Errata to IEEE Recommended Practice for Motor Protection in Industrial and Commercial Power Systems

Correction Sheet 8 December 2021

Figure 11—Thermal overload curves, a) cold and b) warm

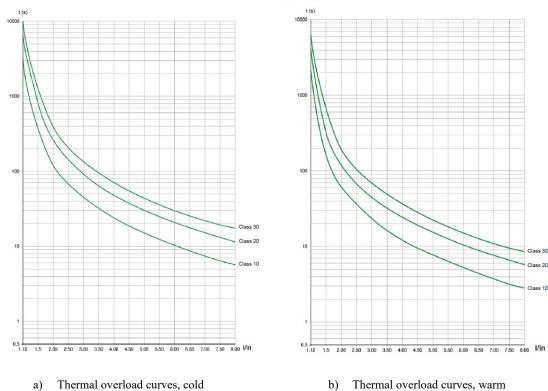
In subclause 6.10, switch the positions of Figure 11a) and Figure 11b) to display as follows:
